PLANNING COMMISSION AGENDA

Thursday, July 19, 2012

Coon Rapids City Center

Subject: PC 12-14 North Suburban Eye Specialists Site Plan Office Building

3 LANDSCAPE PLAN
 L1.1 1" = 20'-0"

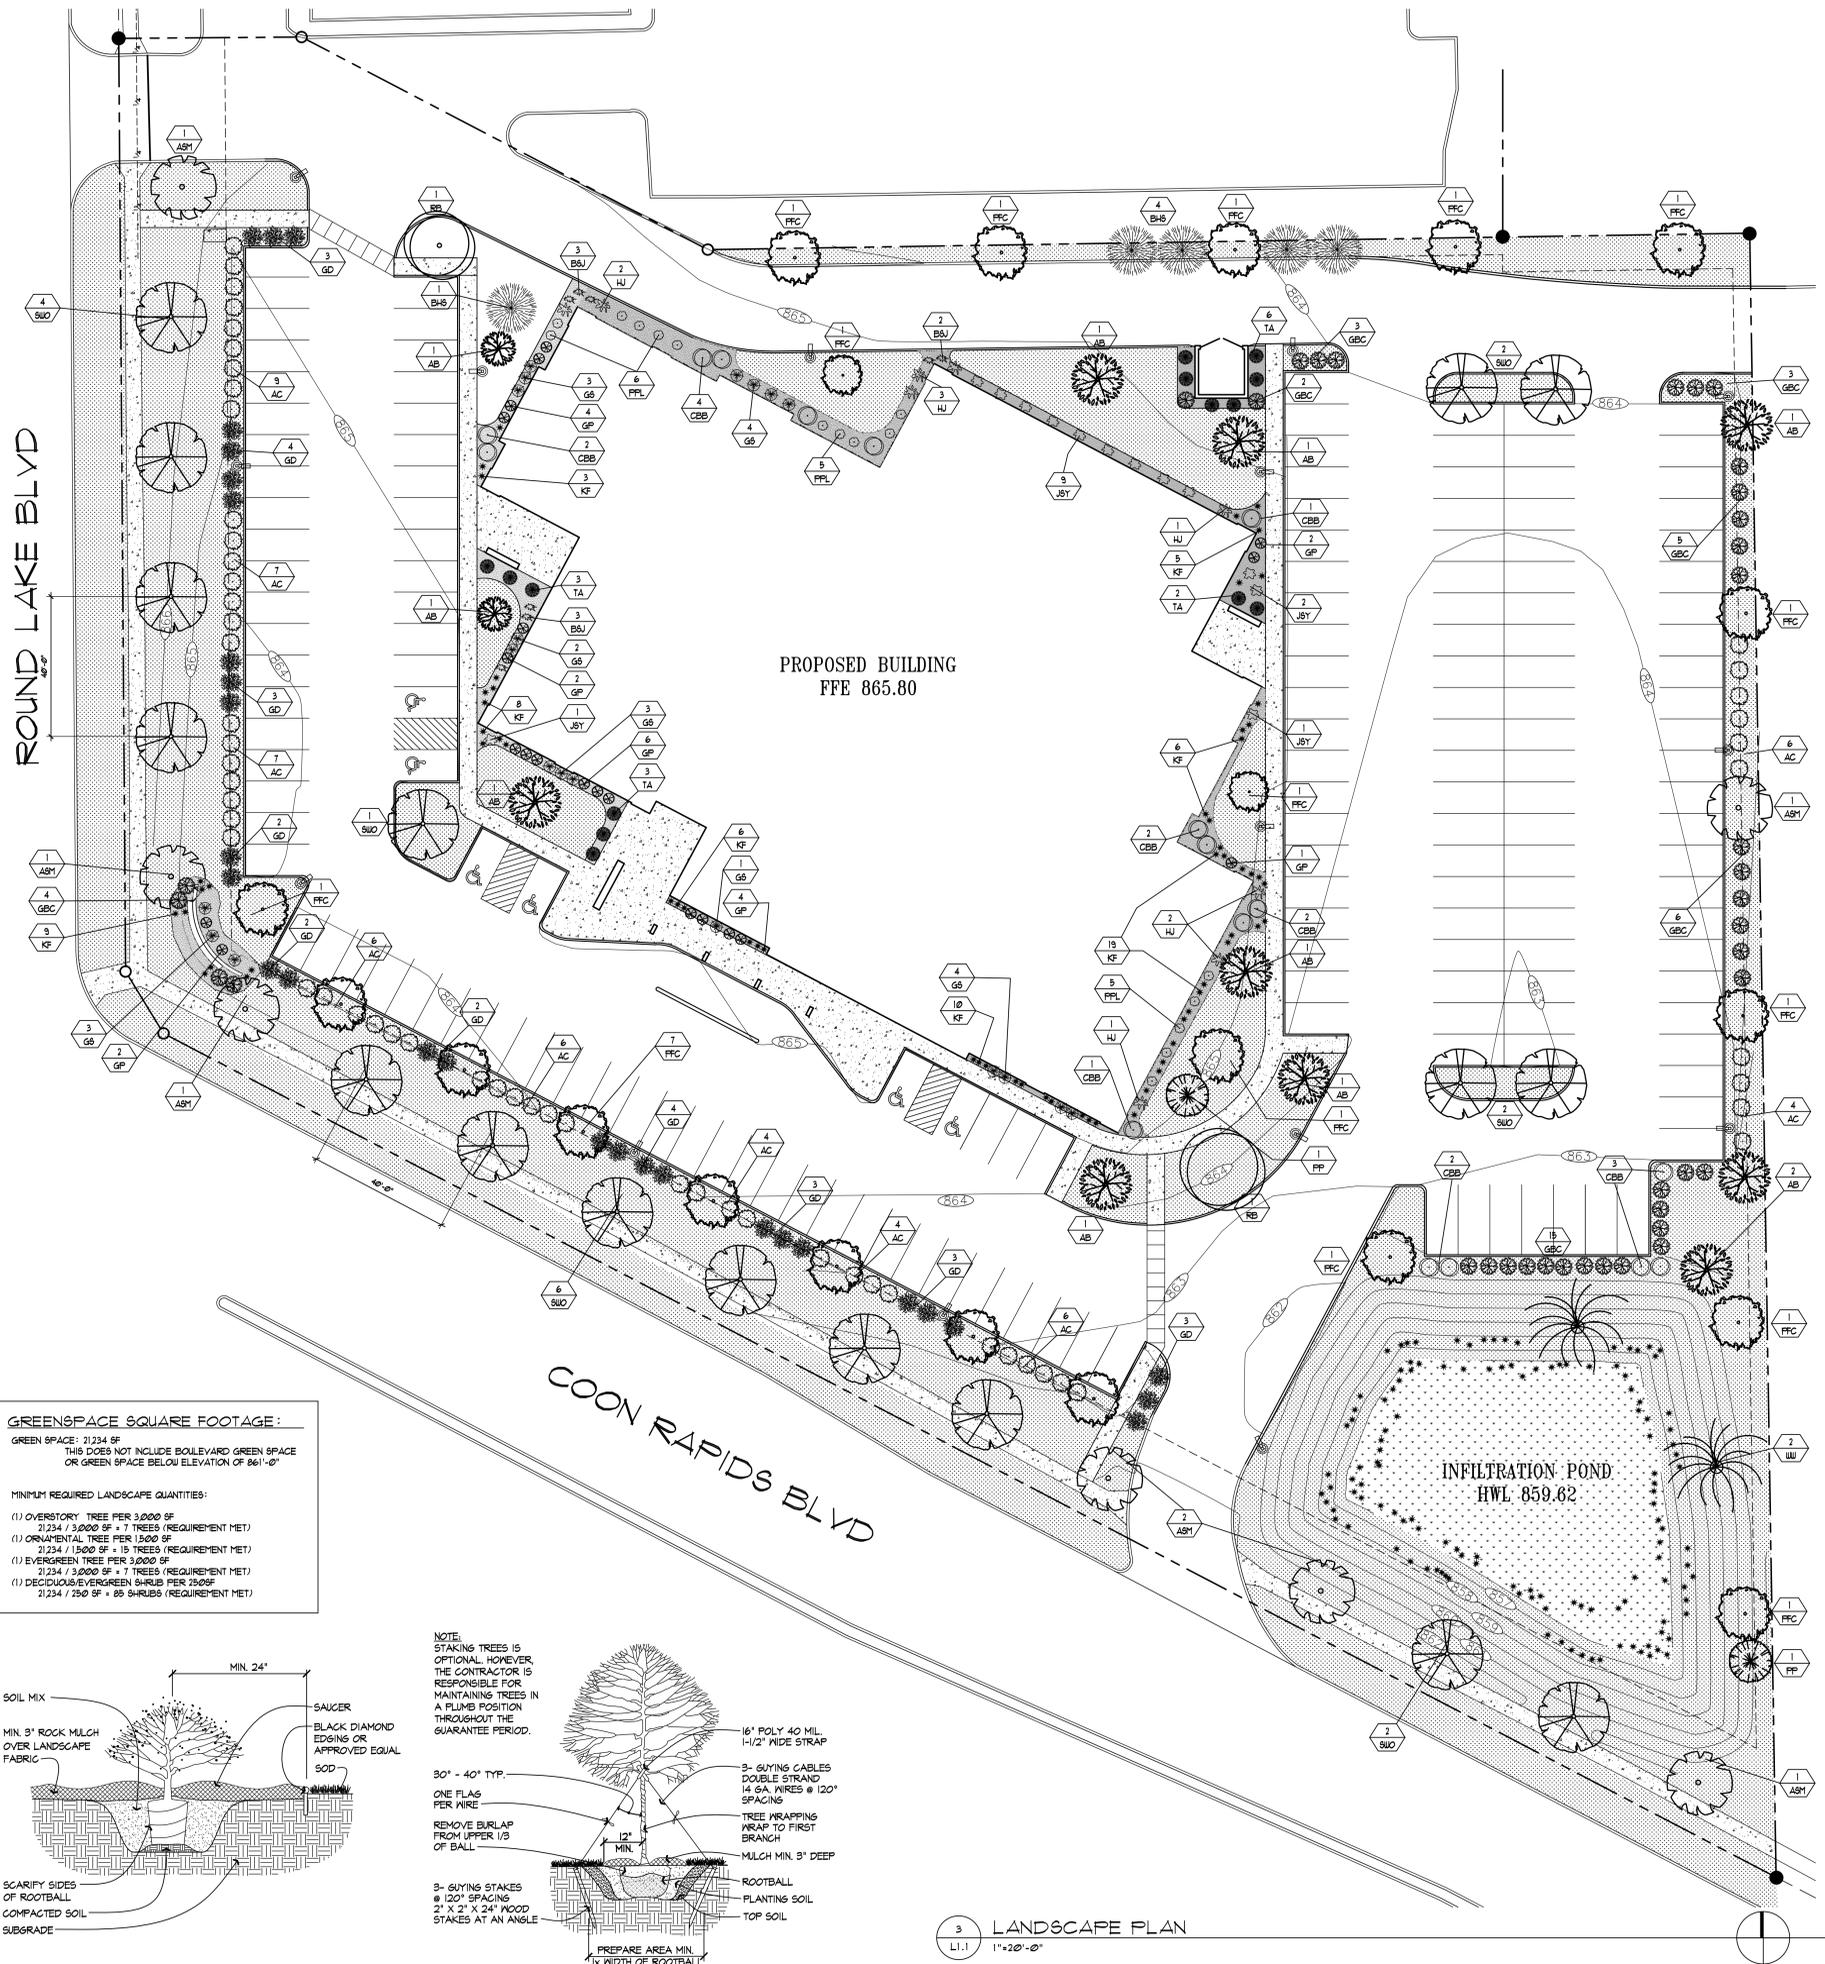
The landscape plan does not include the required number of overstory trees along Coon Rapids Boulevard. The code requires overstory trees planted at 25 foot intervals, the plan has them planted at 30 foot intervals. The applicant proposed 30 foot intervals to allow the trees more room to grow. If planted 25 feet apart, there is not enough room for mature trees. The applicant proposed to include seven ornamental trees be planted along the parking lot to provide the additional trees along Coon Rapids Boulevard. The plan needs an additional 20 shrubs. The code requires 103 shrubs and the plan shows 83.

The site plan includes 21,212 square feet of green space. The landscape plan requires one additional overstory tree; otherwise, the plan complies with the green space landscaping requirements.

The parking area has sufficient landscaping to comply with the code. The landscaping in the common median with the project to the east is compatible with what was shown on their approved landscape plan. Foundation plantings on the side facing Coon Rapids Boulevard is required at a ratio of one shrub per linear foot of building frontage. The facade facing Coon Rapids Boulevard is 150 feet and requires 150 shrubs. Twenty-two shrubs are proposed along with 20 perennial reed grasses. Perennials are not counted toward the shrub requirement; the plan needs an additional 128 foundation shrubs along the Coon Rapids Boulevard frontage.

1. Seating areas and trash receptacles be provided at the entrances.
2. The landscape plan be revised to show an additional green space overstory tree, additional 20 street frontage shrubs and an additional 128 foundation shrubs along the Coon Rapids Boulevard building frontage.
3. The property owner establish a maintenance program for the rain garden and provide the city with a copy.
